From: Garton, Brittany/PDX
Sent: Tuesday, April 06, 2010 11:00 AM
To: Howie, Douglas (ECY)
Cc: Seidell, Nichole/PDX
Subject: RE: Teanaway Solar Reserve Hydrologic Analysis- Flow Resolution
Attachments: TSR_Short_Duration_Flows.xlsx

Thank you for giving the Washington State Department of Ecology (Ecology) the opportunity to review and comment on the Additional Information Submittal materials, which are added to the application for a Conditional Use Permit for the Teanaway Solar Reserve (TSR).

Subject: Response to Department of Ecology Comments Provided on the Additional Submittal Materials Teanaway Solar Project Hydrologic Analysis

FIGURE 3
Proposed Site Layout with Drainage Basins
 Hydrologic Analysis
 Teanaway Solar Reserve
 Kittitas County, Washington

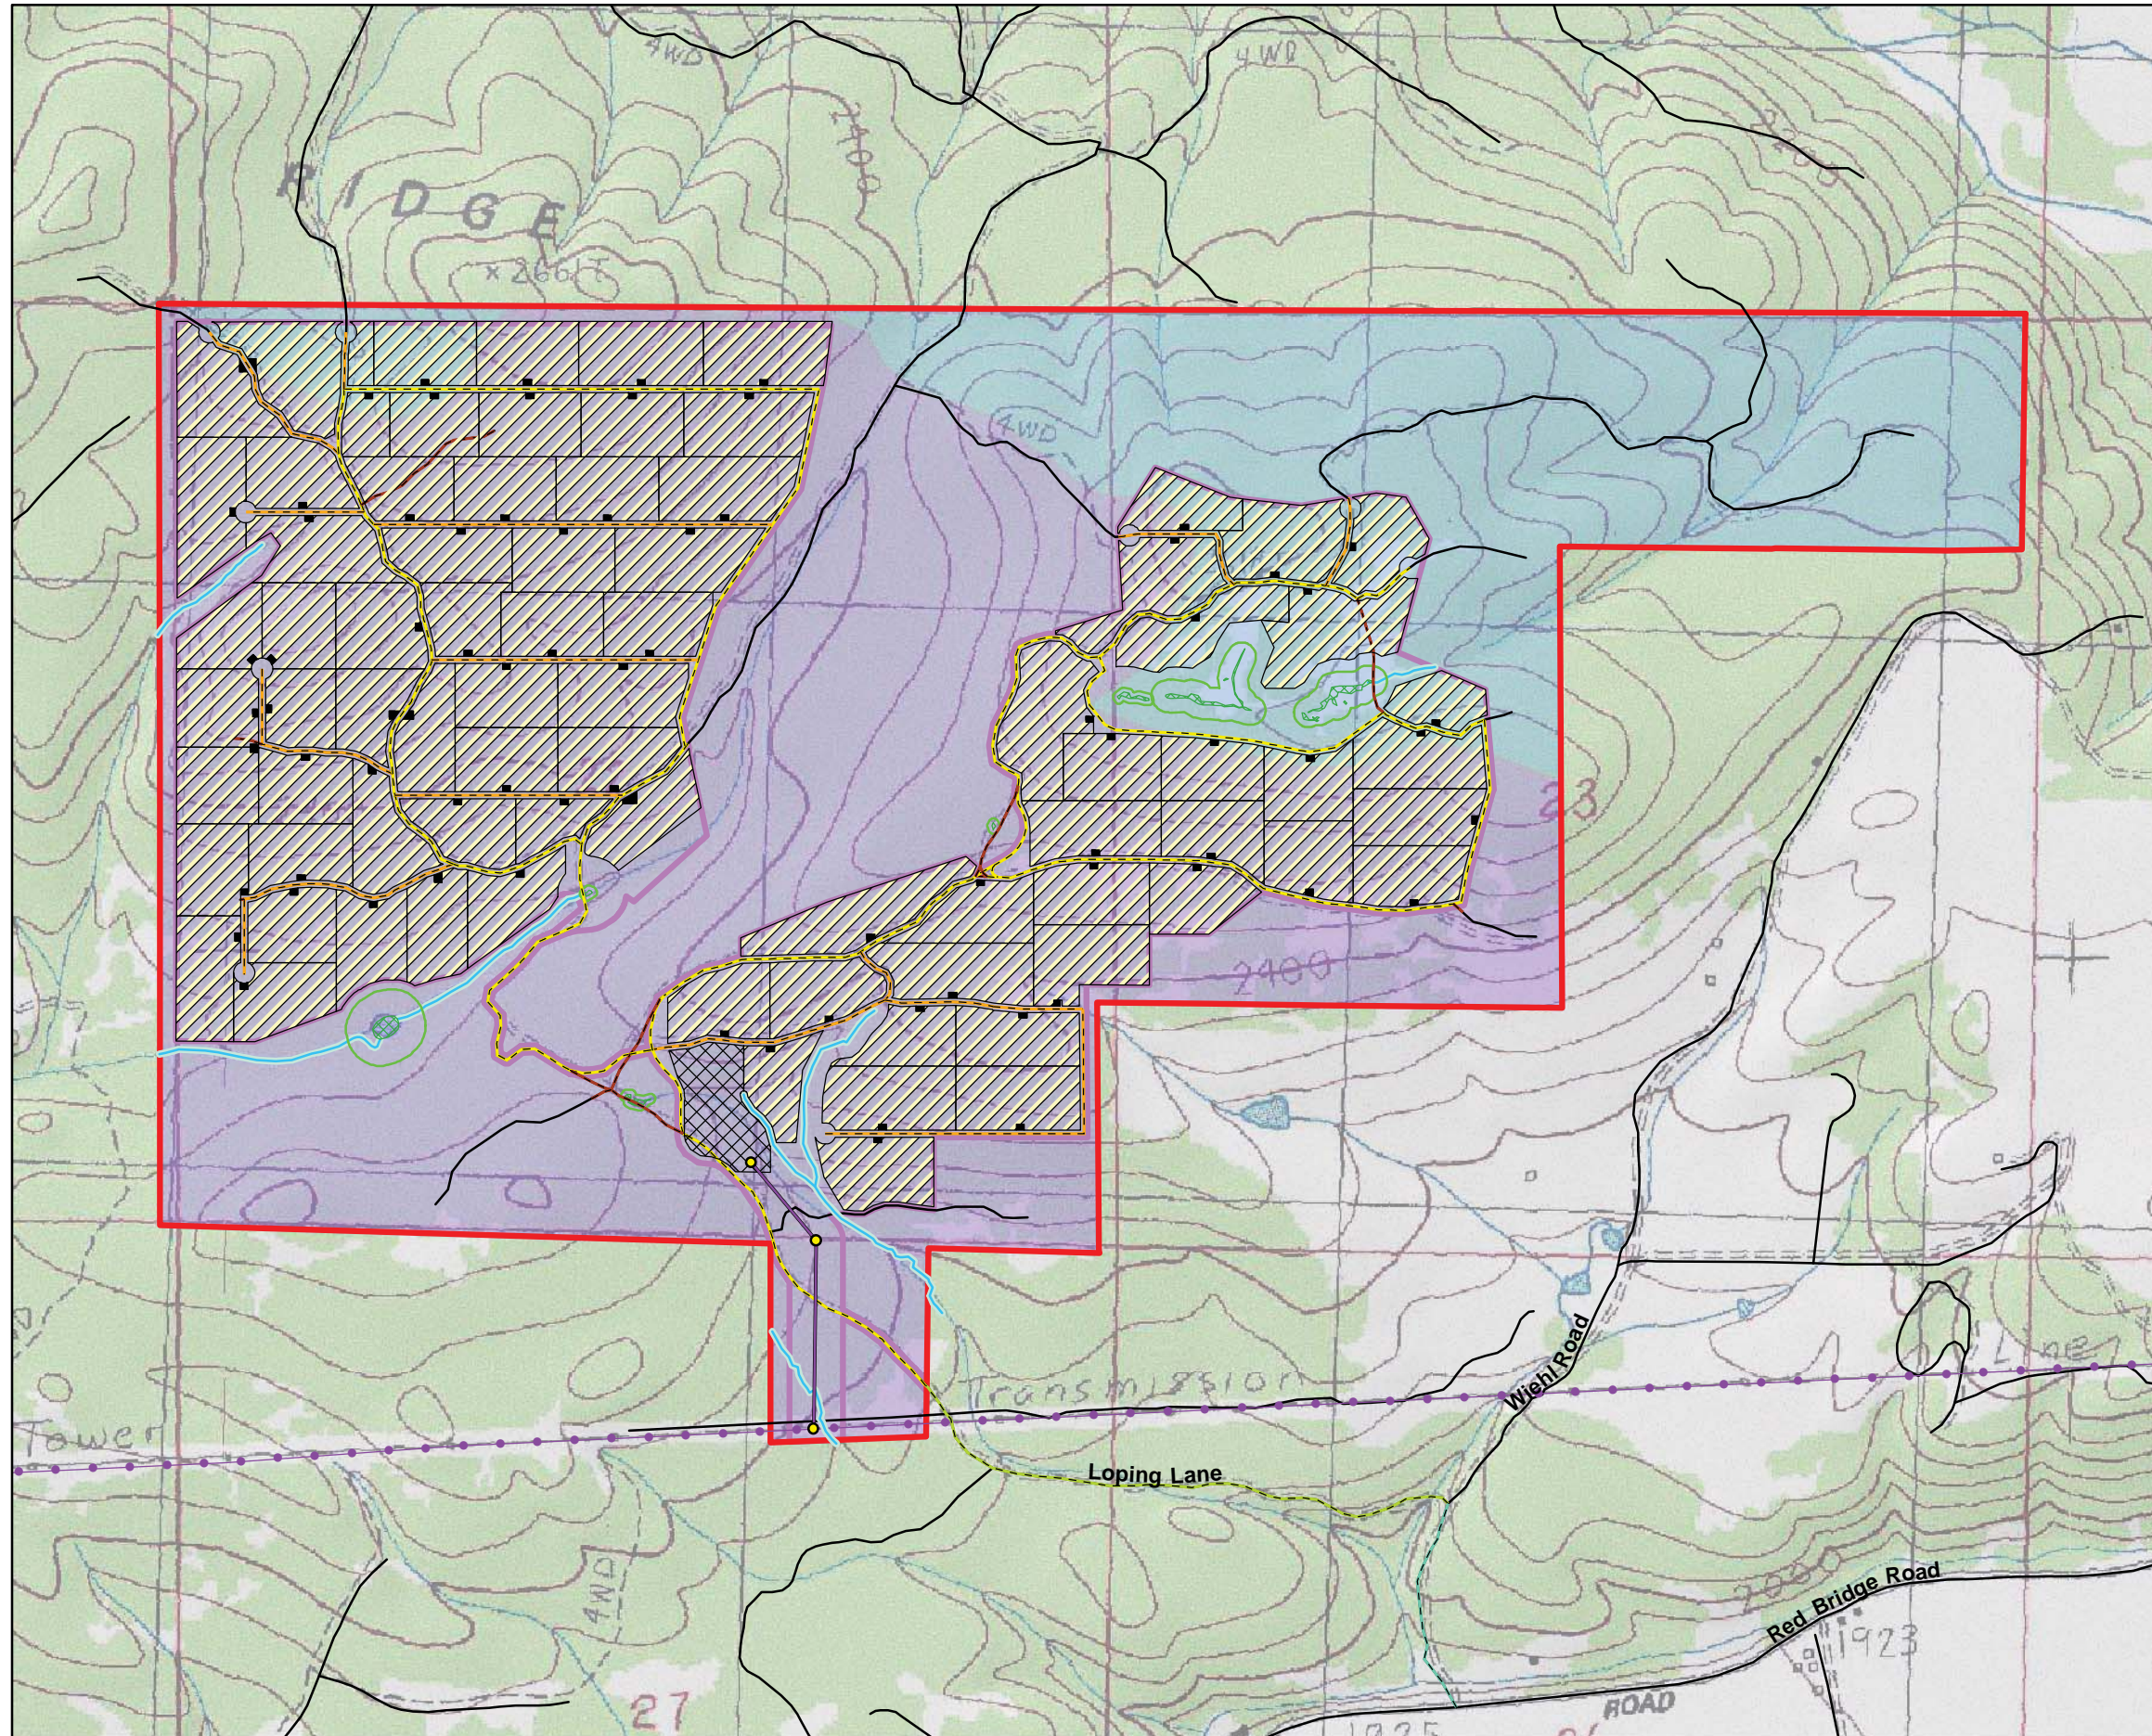
2. Please show the two basin boundaries on the Figure that shows the project boundary. It is difficult to see what part of drainage basin is the project site and what part is outside the project site.

2. Please show the two basin boundaries on the Figure that shows the project boundary. It is difficult to see what part of drainage basin is the project site and what part is outside the project site.

The proposed project site is defined at 477 acres, and the project area is 982 acres. The North drainage basin encompasses 259 acres, of the project area and the South drainage basin encompasses the remaining 723 acres. The basins within the project area are illustrated in purple and blue on Figure 3 (see attached).
